Introduction

The PIC16(L)F1934/1936/1937 devices that you have received conform functionally to the current device data sheet (DS41364E), except for the anomalies described in this document.

The silicon issues discussed in the following pages are for silicon revisions with the Device and Revision IDs listed in the table below.

Figure 1-1. Instruction Cycle Delay Calculation Example

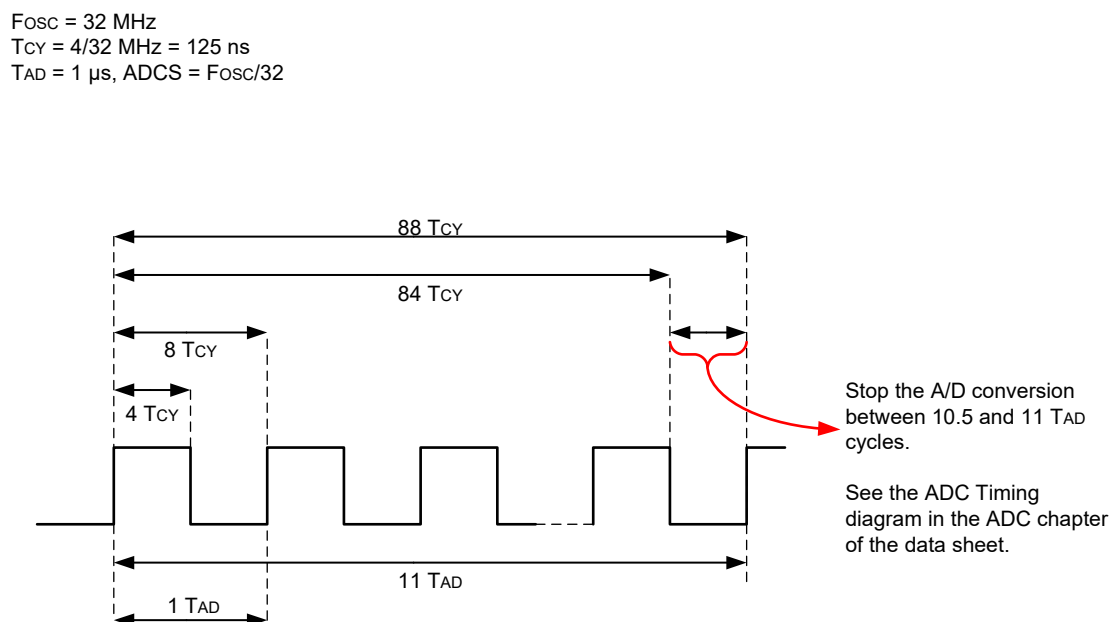
1. When F_{OSC} is greater than 8 MHz and it is the clock source used for the ADC converter.
2. The ADC is operating from its dedicated ADCRC oscillator and the device is not in Sleep mode (at any F_{OSC} frequency). When this occurs, the ADC Interrupt Flag (ADIF) does not get set, the GO/DONE bit does not get cleared, and the conversion result does not get loaded into the ADRESH and ADRESL result registers.

In [Figure 1-1](#), 88 instruction cycles will be required to complete the full conversion. Each T_{AD} cycle consists of 8 T_{CY} periods. A fixed delay is provided to stop the A/D conversion after 86 instruction cycles and terminate the conversion at the correct time.

Note: The exact delay time will depend on the T_{AD} divisor (ADCS) selection. The T_{CY} counts shown in [Figure 1-1](#) apply to this example only. Refer to [Table 1-1](#) for examples of the required delay counts for other configurations.

This method is provided if the application cannot use Sleep mode and requires continuous operation at frequencies above 8 MHz. This method requires early termination of an ADC conversion. Provide a fixed time delay in software to stop the ADC conversion manually, after all 10 bits are converted, but before the conversion would complete automatically. The conversion is stopped by clearing the GO/DONE bit in software, and must be cleared during the last $\frac{1}{2} T_{AD}$ cycle, before the conversion would have completed automatically.
